Re: Blake's Lotaburger #34 Building and Drive Thru Addition,  
3700 4th Street NW, Traffic Circulation Layout  
Architect's Stamp dated 04-14-10 (G14-D052)

RE: TCL Re-Submittal - Blake's Lotaburger #34 Building and Drive-Through Addition, 3700 4<sup>TH</sup> Street NW

**Re: Blake's Lotaburger #34 Building and Drive Thru Addition,  
3700 4<sup>th</sup> Street NW, Traffic Circulation Layout  
No Architect's Stamp (G14-D052)**

BLANCK'S 4TH & CANDELARIA  
APPROX AREAS BY APPROX  
PELY LINES

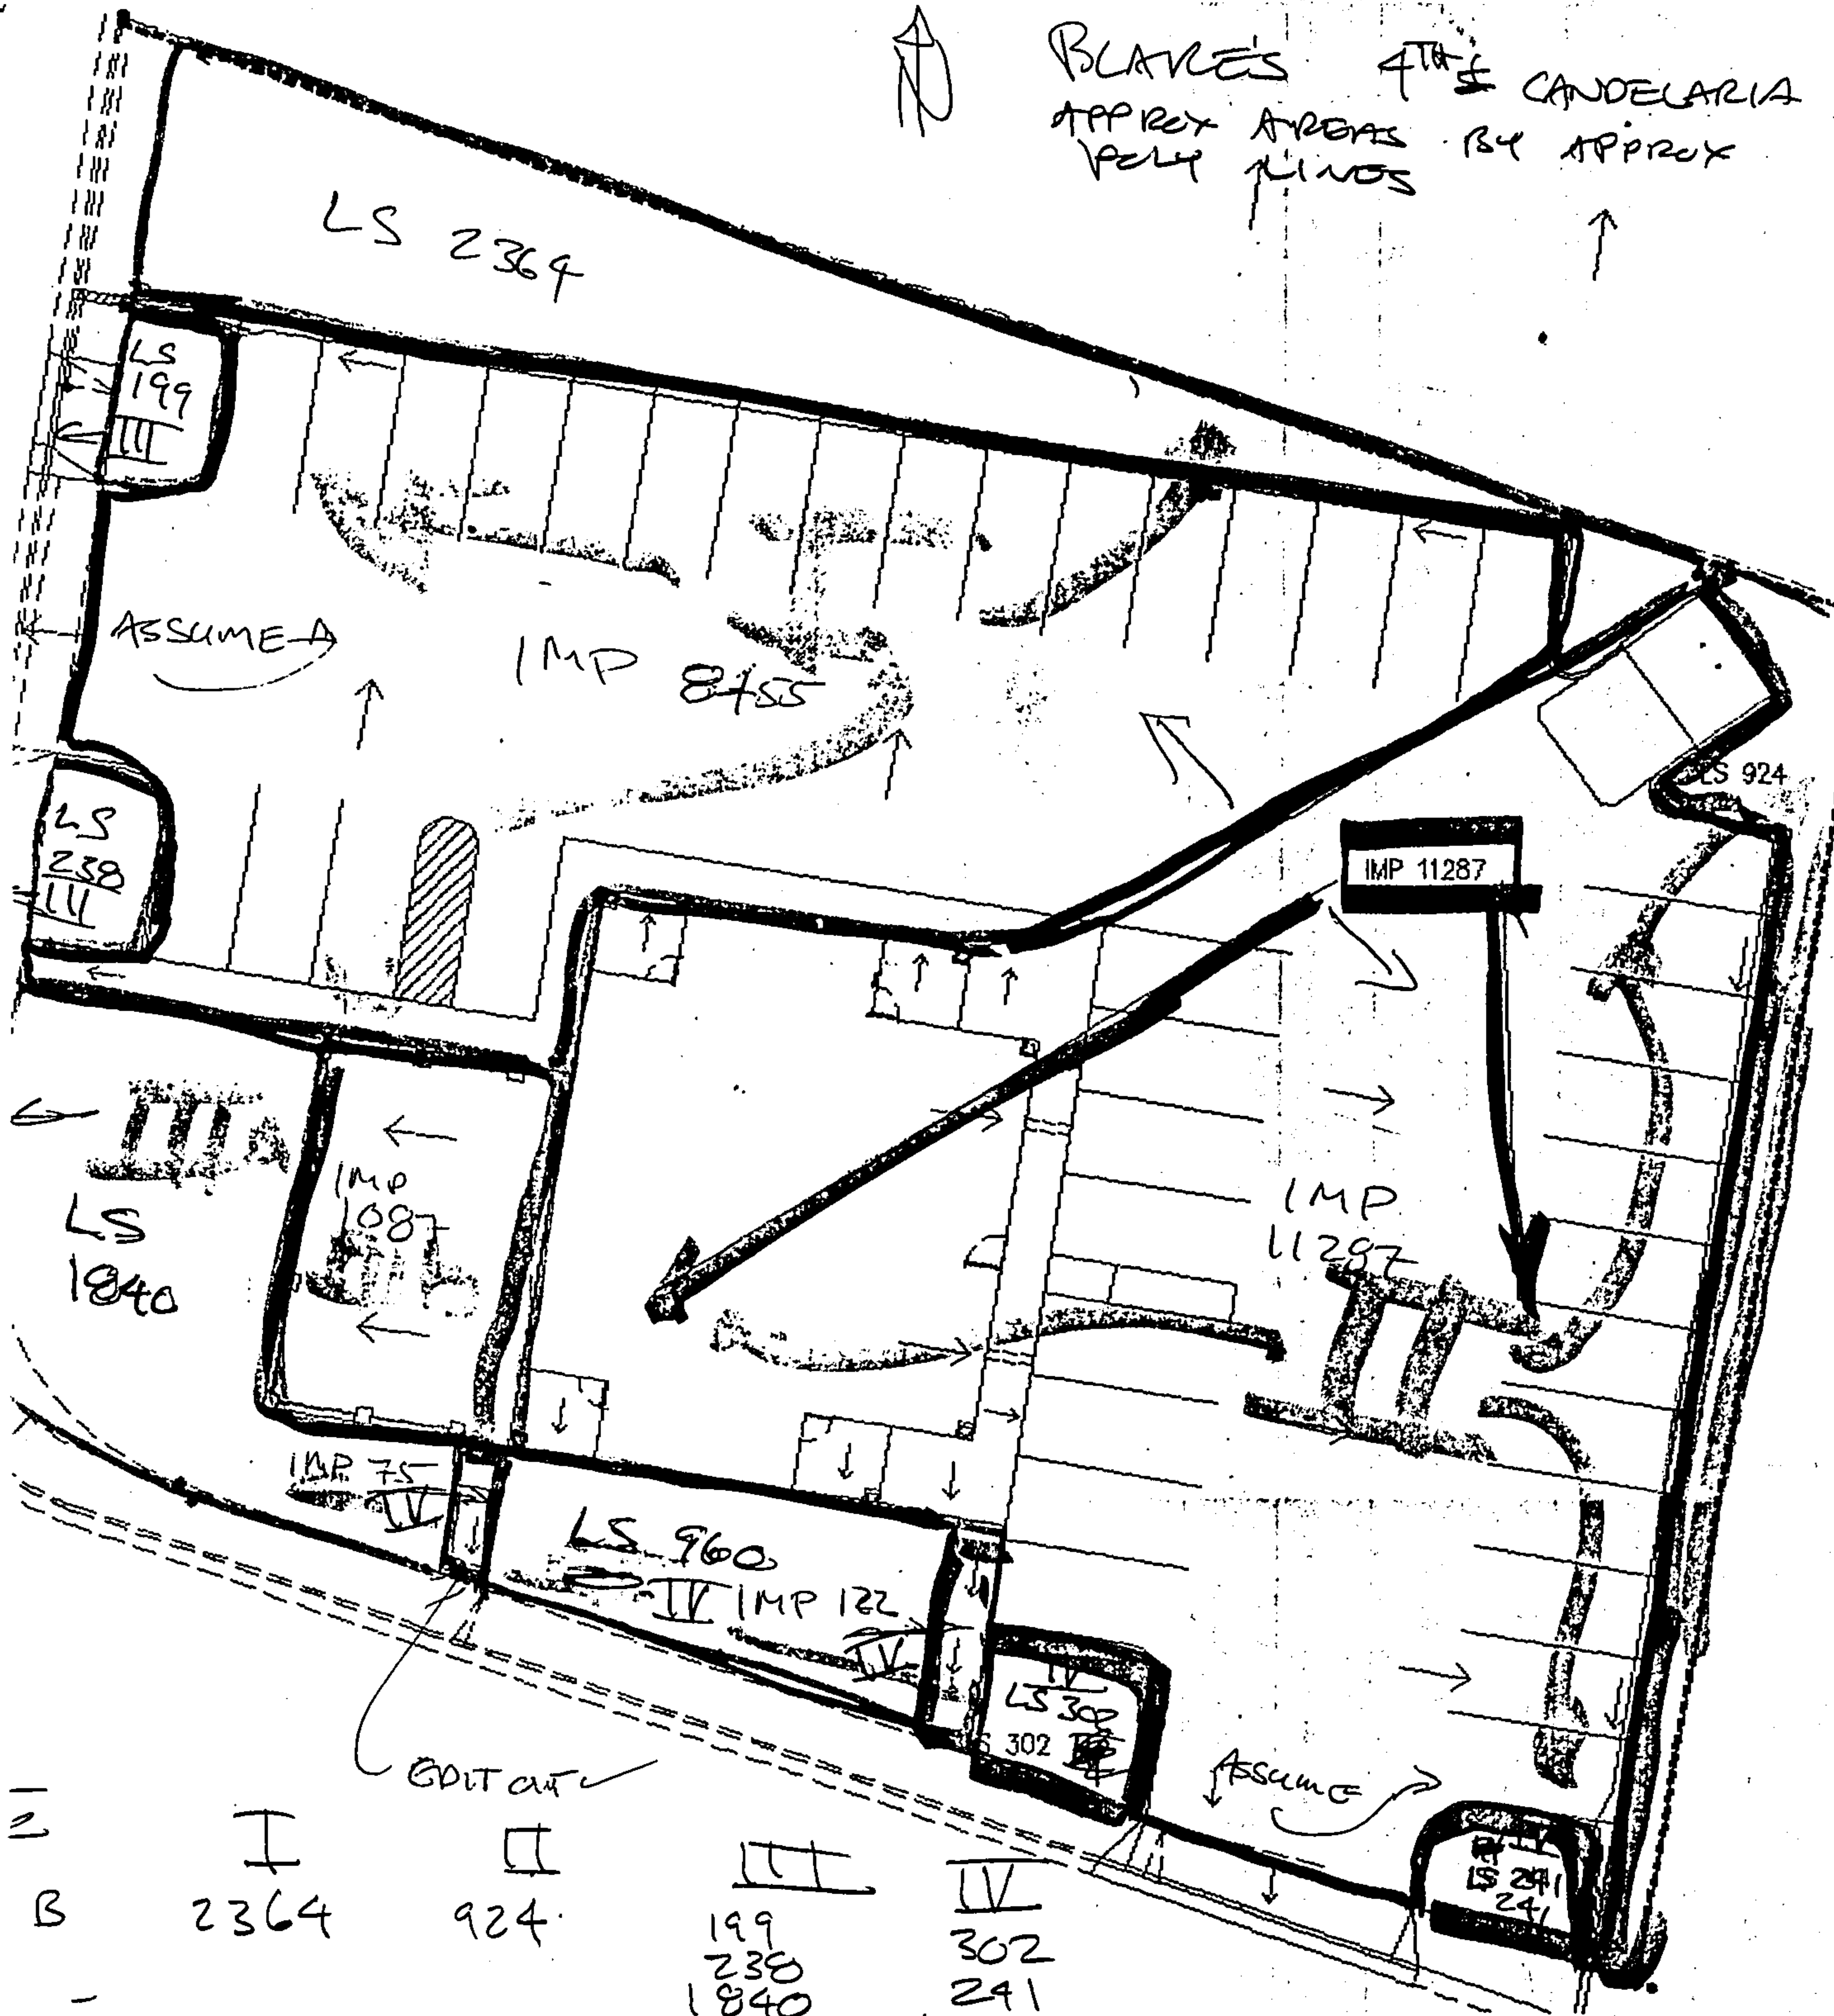
- ✓ 1. Copy of approved filed replat.
2. T.B.M. must be located in close proximity to the job site and must be permanently established.
3. No developed run-off is allowed across a public sidewalk. It must be routed to the asphalt area.
4. Please provide the calculations for the capacity of each sidewalk culvert using the orifice equation.
5. Two (2) copies of plan with resubmittal.
